# New Service Station at 2135 Washington Avenue

Service Station at 21-35 Washington Ave, corner of Cumberland  
2/13/63

Permit to construct a one story three-bay service station 62'6" x 29'4" as per revised plans and specifications received April 29, 1963 and in accordance with Mr. Sears letter of March 13, 1963 is being issued subject to compliance with the following:

Although the appeal under the Zoning Ordinance for new service station at the above named location in this City has been sustained conditionally, permit for its erection cannot be issued until information indicating compliance with Building Code requirements has been furnished. Rights granted under the appeal will expire unless work is started within six months of the date on which the appeal was sustained. Items and details in question are as follows:

PROPOSED PLOT PLAN OF  
SERVICE STATION TO BE CONSTRUCTED  
AT WASHINGTON & CUMBERLAND AVES.  
PORTLAND, MAINE

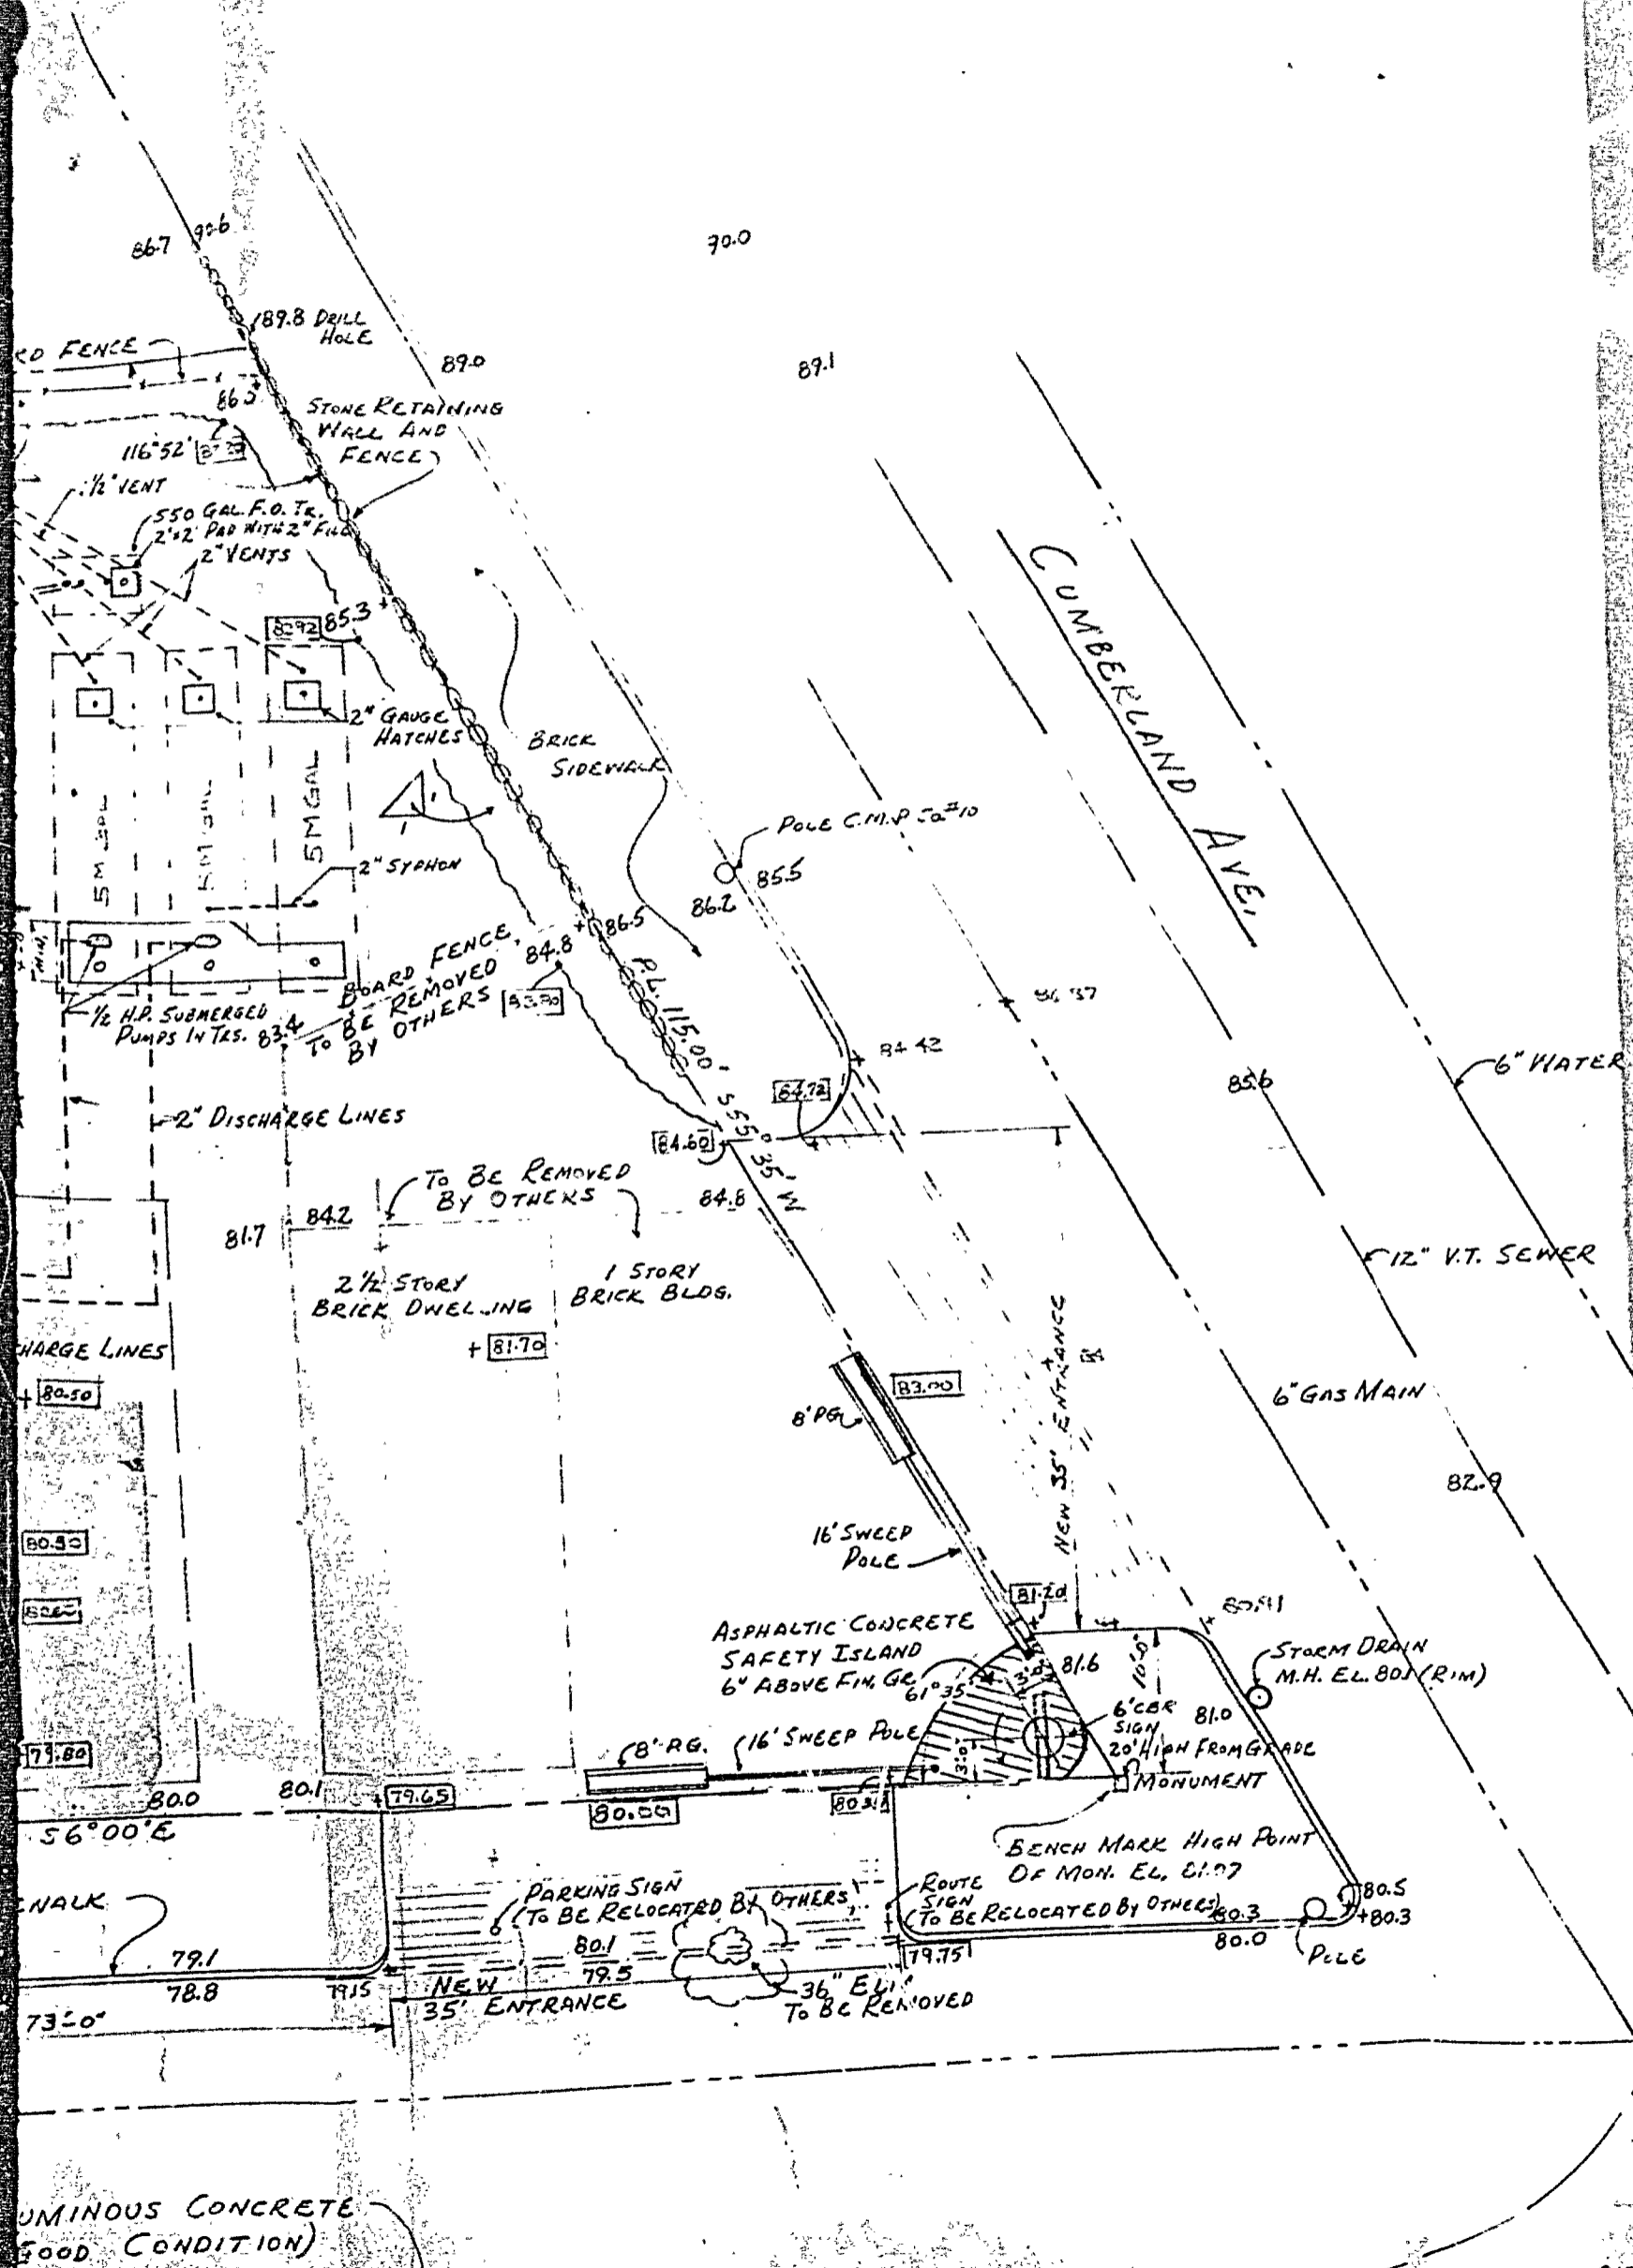
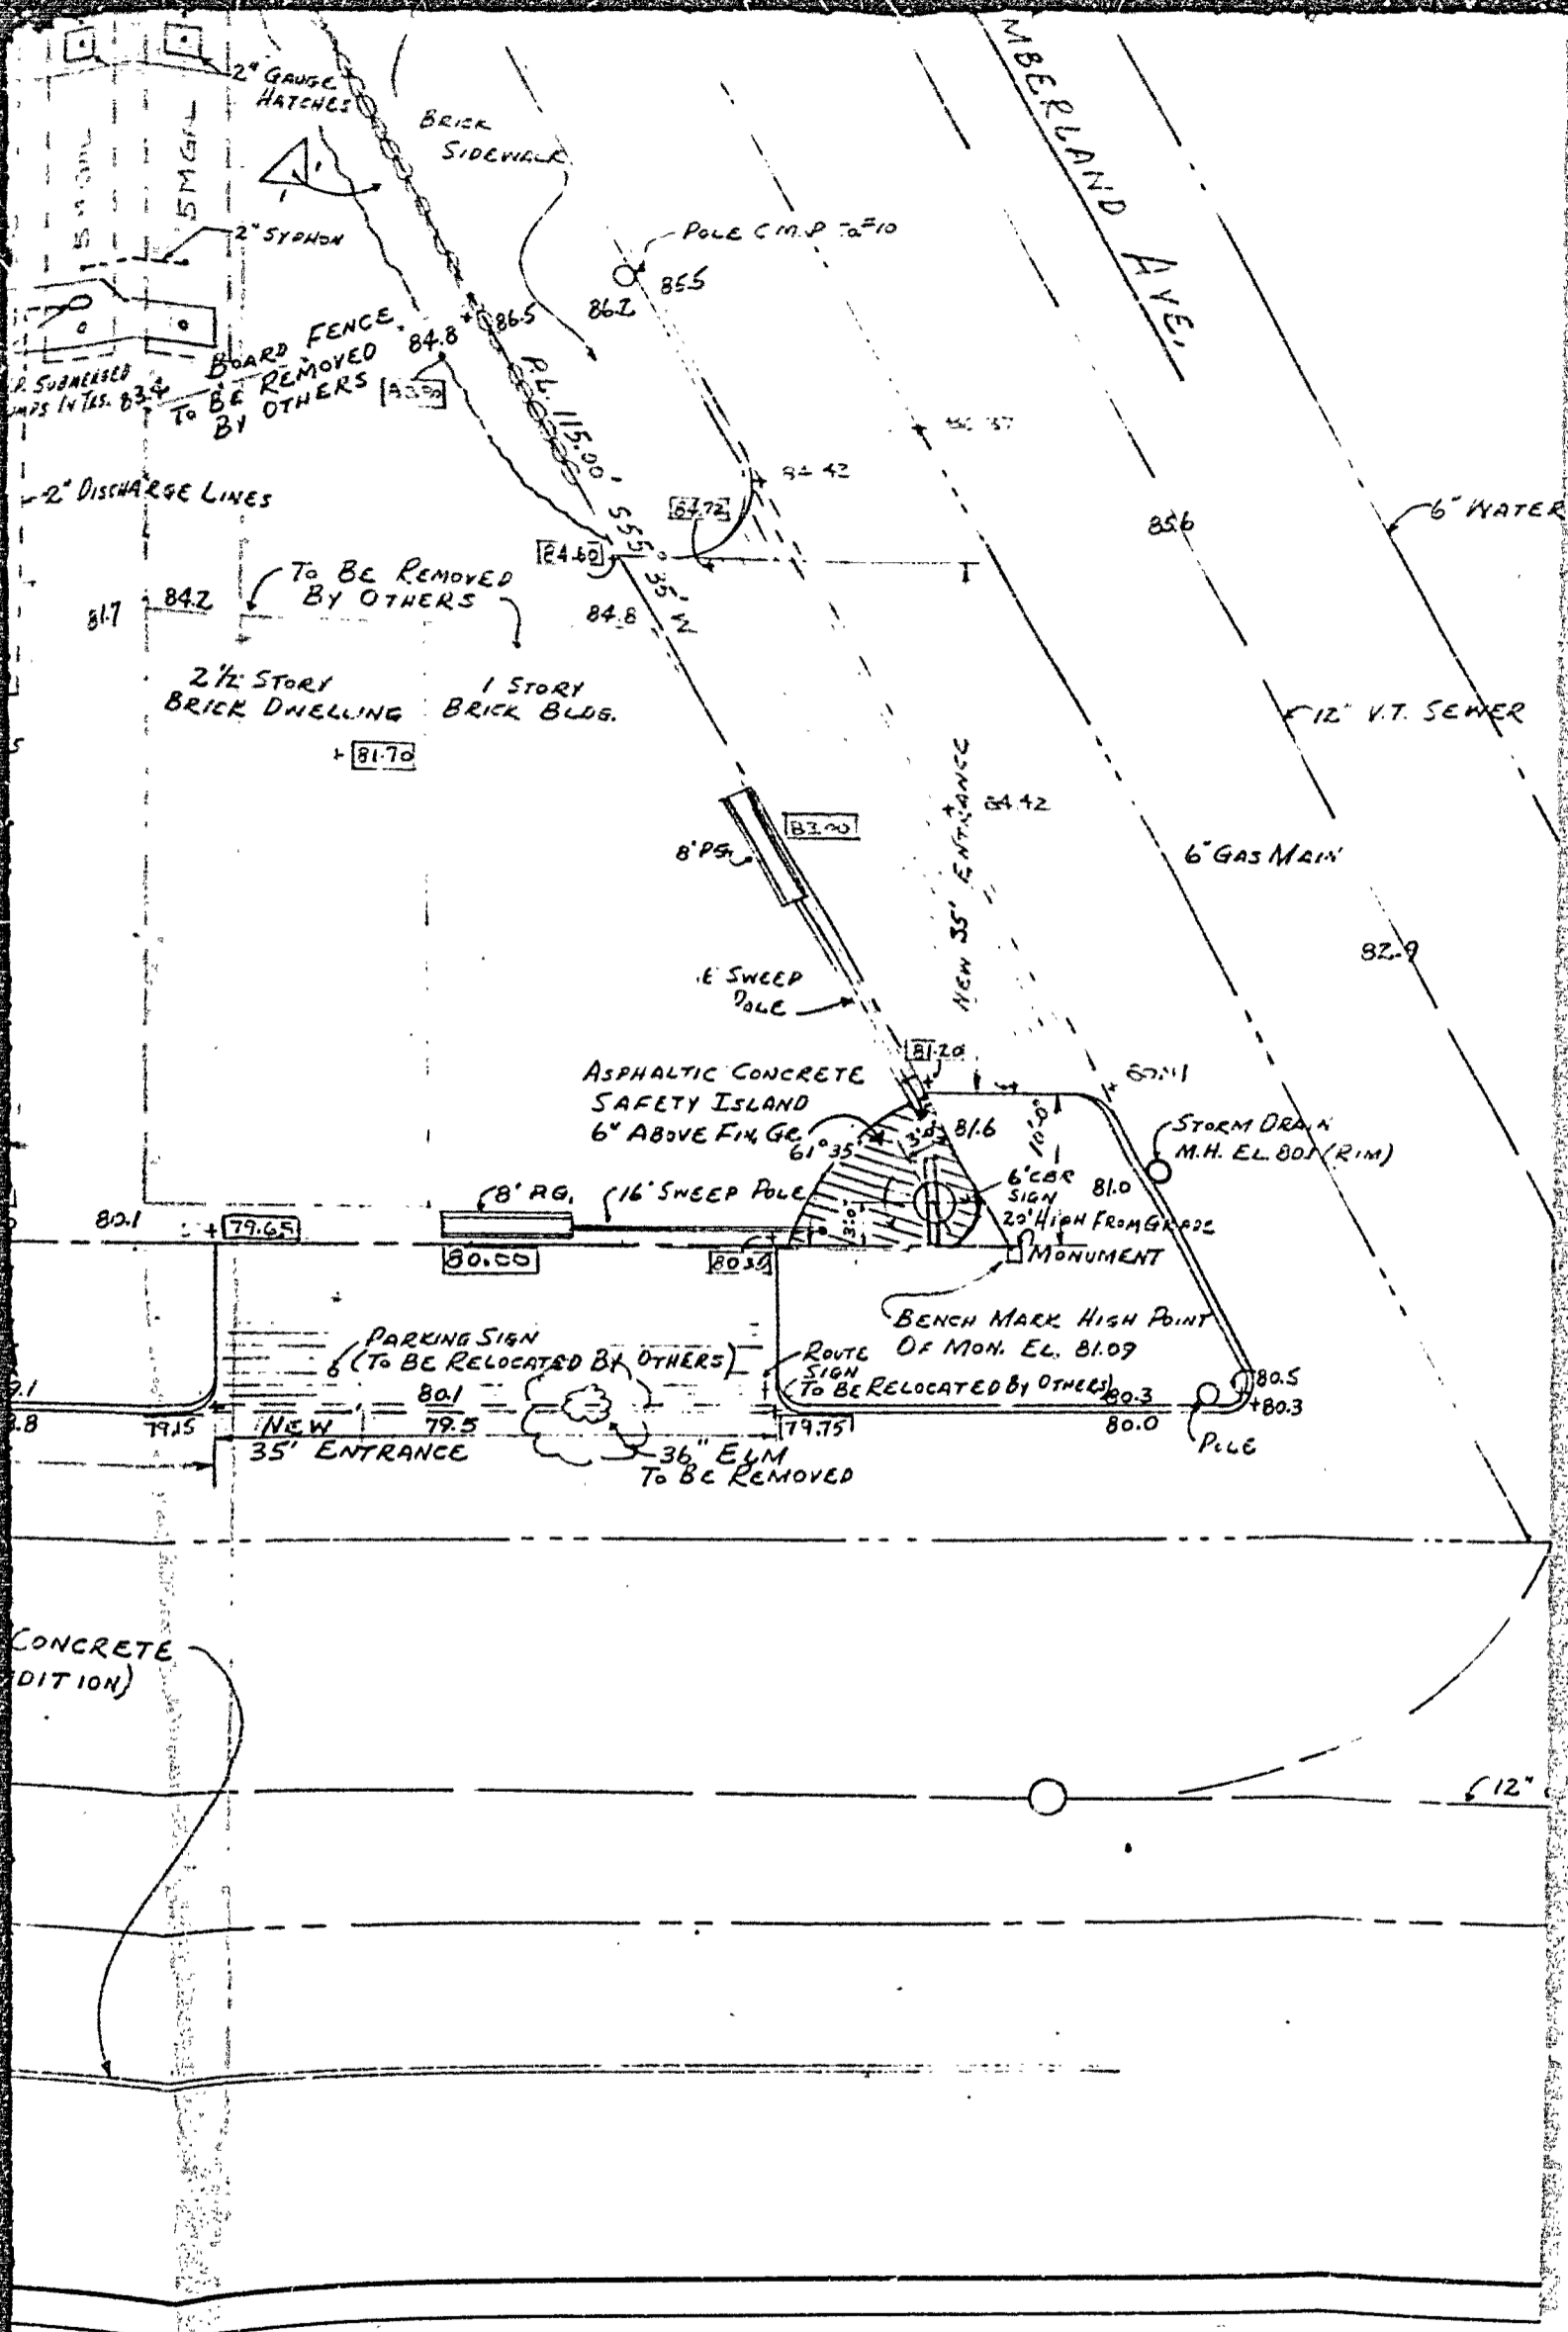
OK as to location and  
dimension of driveway opening.

OK as to location and  
dimensions of driveway openings.  
A.H. Connor
